**324 N. Main Street, Davenport IA – Partial Collapse
Preliminary Investigative Report**

LF232566 / WBG202306
August 15, 2023

Mr. Thomas Warner
Corporation Counsel
City of Davenport
1200 East 46th Street
Davenport, IA 52807

White Birch Group, LLC

Fig. 15. Photograph from May 26, 2023 at approximately 3pm. Annotation by WBG and SEI.

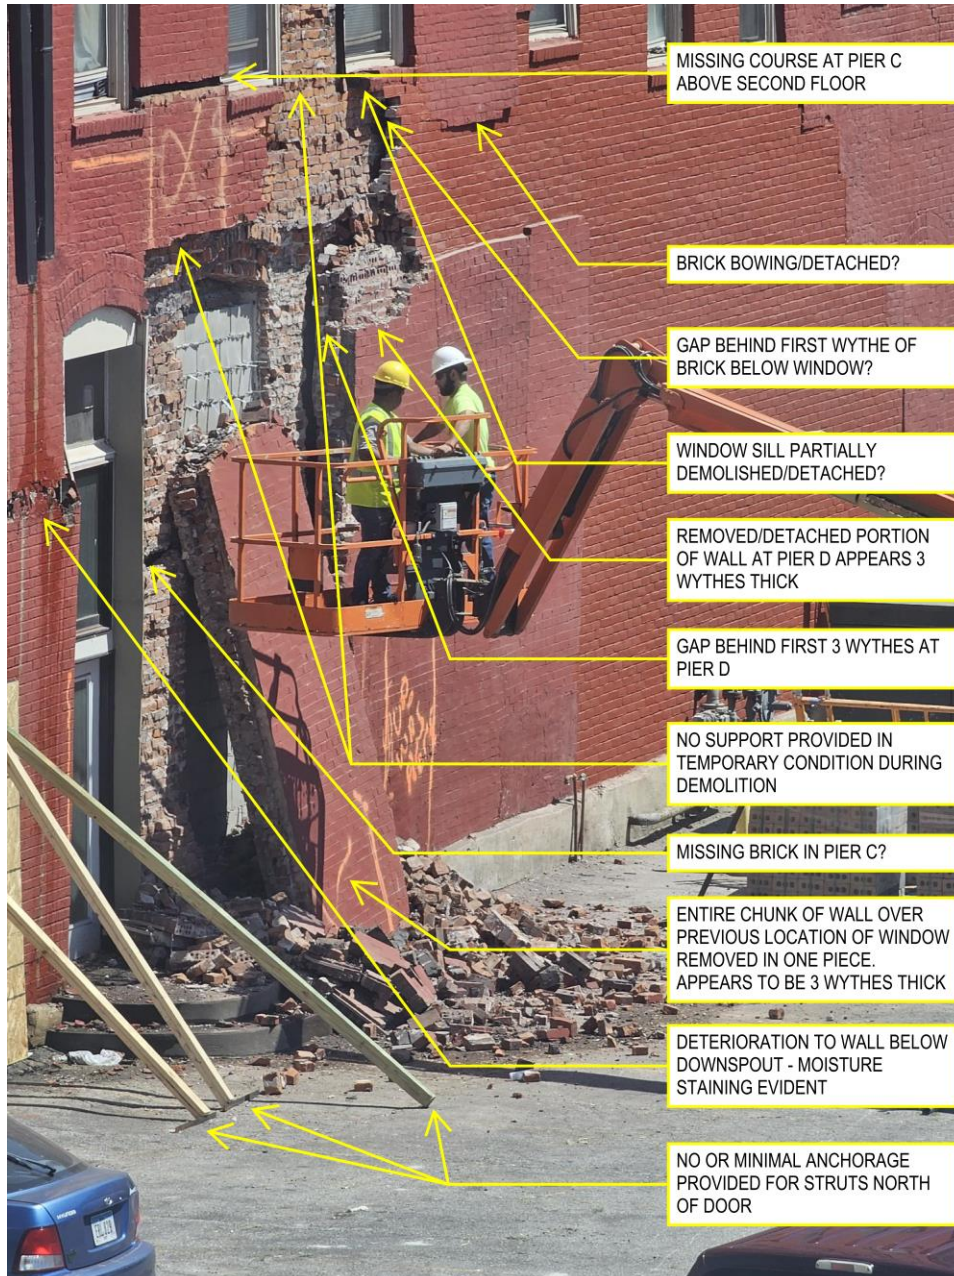
On May 26, 2023 (two days prior to collapse), a photograph was taken of the ongoing repair work at the building. An annotated version of this image is provided in **Fig. 15**. The image indicates several areas of nonconformance with the repair specifications issued by SSE, in addition to other deficient conditions.

Fig. 25. Configuration of wall resulting from early 2023 repair project

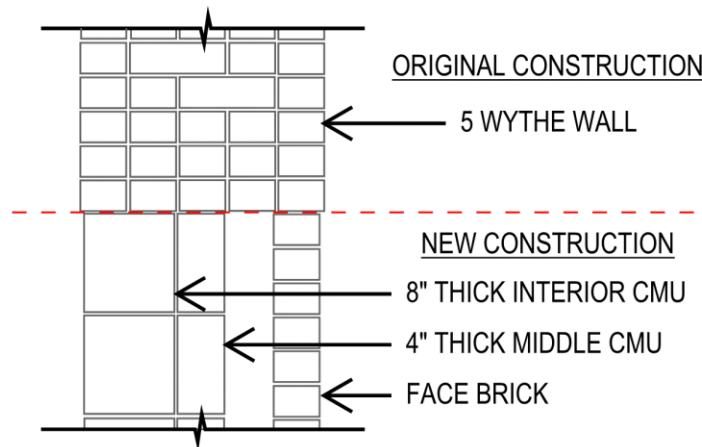
The new wall construction generally consisted of two wythes of CMU, a cavity, and a single wythe brick masonry veneer (see **Fig. 25**). Unlike the composite multi-wythe masonry of the floors above, the wythes in the new construction were not laterally tied together with headers or other shear ties to form a composite wall construction. Although corrugated steel veneer anchors were installed in some of the new CMU, these ties are typically designed only to provide lateral support for a veneer, not to engage the backup wall compositely through shear. Regardless, these ties were not engaging the exterior wythe of brick masonry (**Photograph 20**).

Further, since the new CMU wall construction did not provide continuous bearing support for all 5 wythes of the masonry bearing wall above, and left one of the intermediate wythes vastly unsupported (**Photograph 18** and **Photograph 19**) some of the unsupported brick masonry above became disengaged, and the loose brick fell and collected at the base of the first-floor wall cavity between the CMU backup and the outer brick veneer. This condition exacerbated the wall distress by exerting additional forces on the brick veneer. The accumulation of loose masonry was reported by SSE in their Addendum letter dated February 28, 2023 (**Photograph 21**).

Fig. 34. Figure 1 from SSE’s February 8, 2023 letter indicating the area of specified repair.

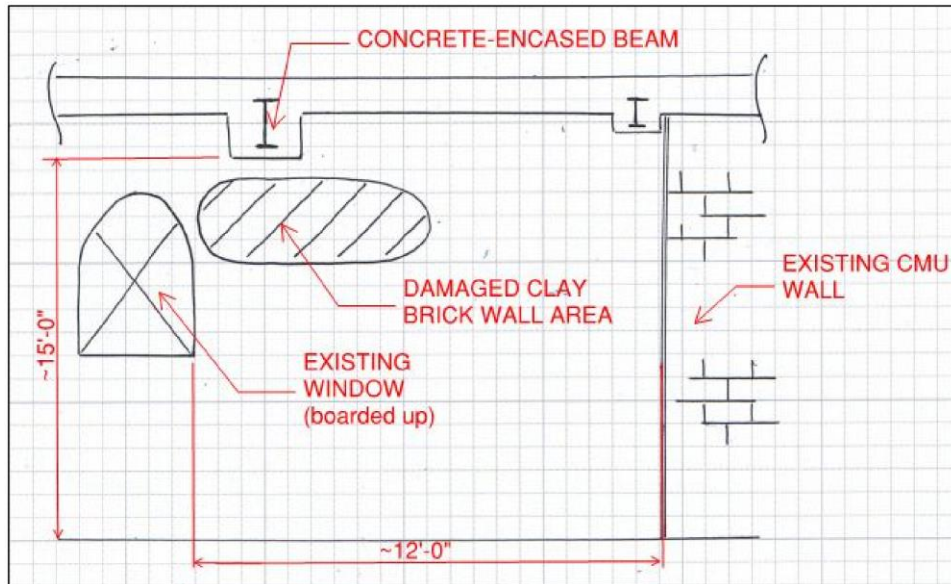
Figure 1 from the letter (included as **Fig. 34** in this report) indicates the extents of the observed distress (and therefore area of repair) as viewed from inside the building.

Fig. 36. Figure 8 from SSE's February 8, 2023 showing needle beams and angles.

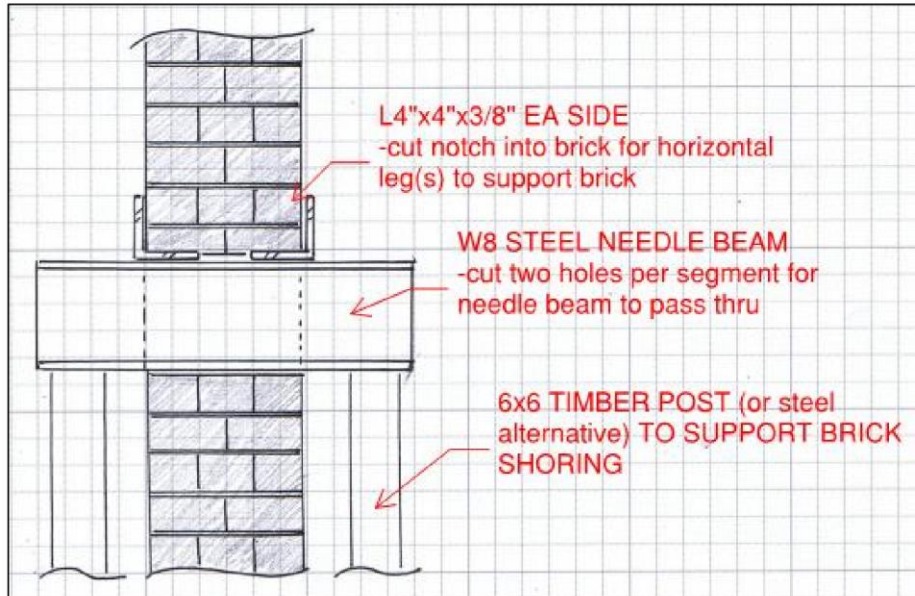
Further, SSE's "Figure 8" contained within the February 8, 2023 (**Appendix A: Fig. 36**), letter delineates a 3-wythe masonry wall, instead of the 5-wythe wall that existed. Although no scale is indicated, the dimensions assigned to the shoring elements contained in the drawing suggest a total wall thickness of approximately 12 in. and the original SSE replacement design only specified a single wythe of CMU replacement to support the 5-wythe wall.

This would result in over 12 in. (3-wythes) of unsupported brick masonry above the new CMU. The February 28, 2023, "Addendum" letter from SSE references a site observation by the masonry contractor that resulted in a modification of the original inadequate scope, changing the original installation of a single wythe of CMU to two wythes of CMU. However, the modified scope (**Appendix A: Fig. 38**) still results in more than 5 in. of unsupported wall thickness, and an overall weaker non-composite system.

Figure 8 of SSE's February 8, 2023 letter (included as **Fig. 36** in this report) shows a section through the wall. The wall was drawn as 3 wythes thick (rather than the 5 indicated on the original drawings), with steel angles supporting only the innermost and outermost wythes.

Fig. 37. SSE shoring sketch dated February 9, 2023.

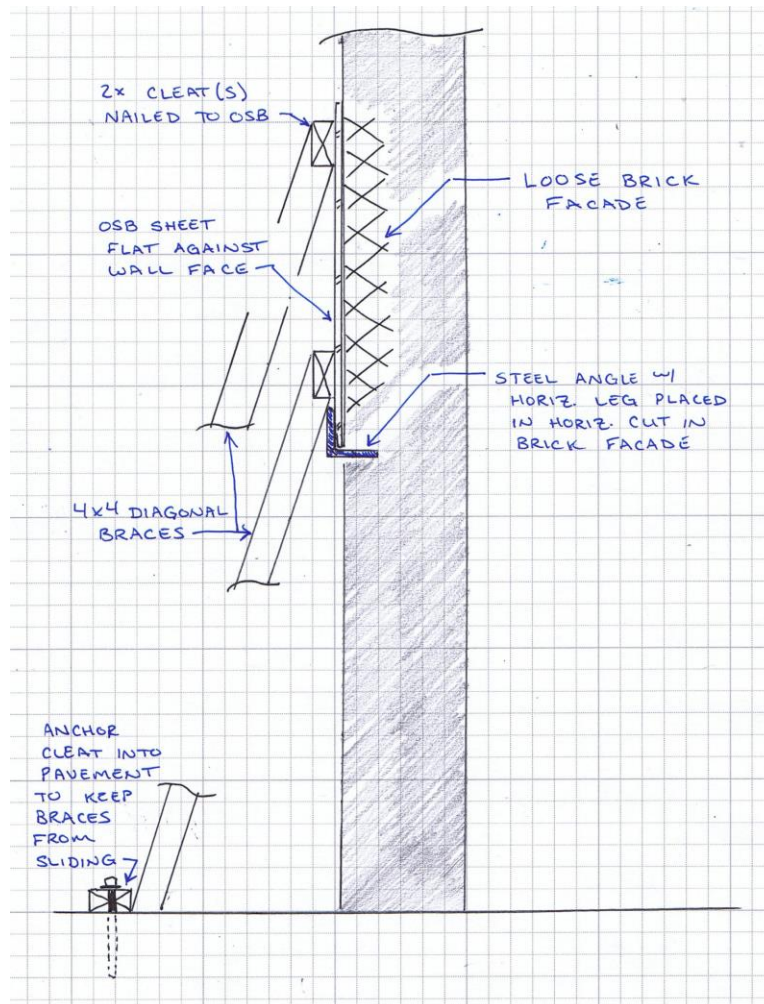
Two photographs were attached to the end of the report. Neither photograph displayed the exterior of the building. No plans or drawings were provided to locate the beams, and no specification was provided for the shoring to be installed.

Photograph 21: Image from SSE February 28 Addendum letter.

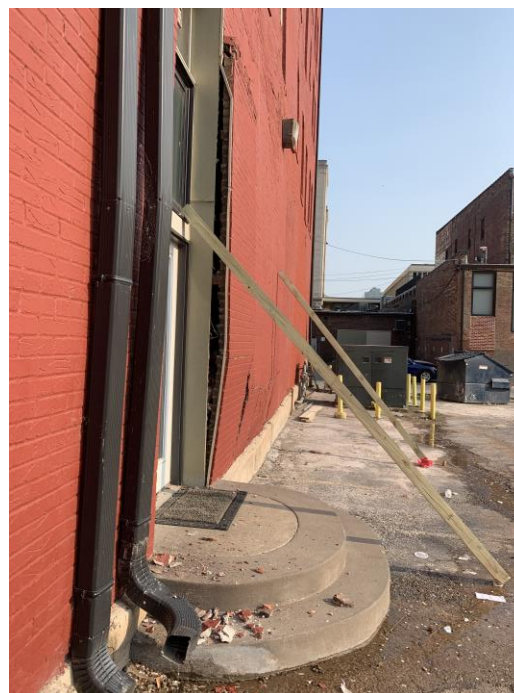
Note cavity between CMU wall and exterior wythes, and unsupported upper wythes of masonry.

Photograph 27: Image from City file 23-30329.
Note mis-aligned masonry at Pier E brick replacement locations.

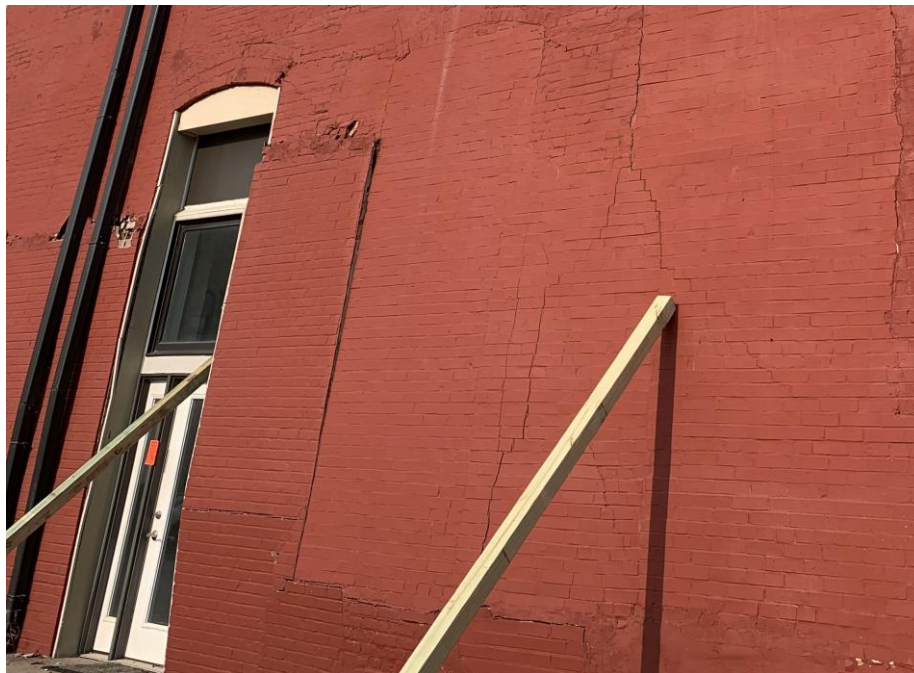
Further, many of the areas comprising previous repairs are not aligned/in-plane with the parent (existing) masonry wall (**Photograph 27**). This creates a lack of continuity, eccentric load path, and reduced capacity to support and transfer loads through the wall system.
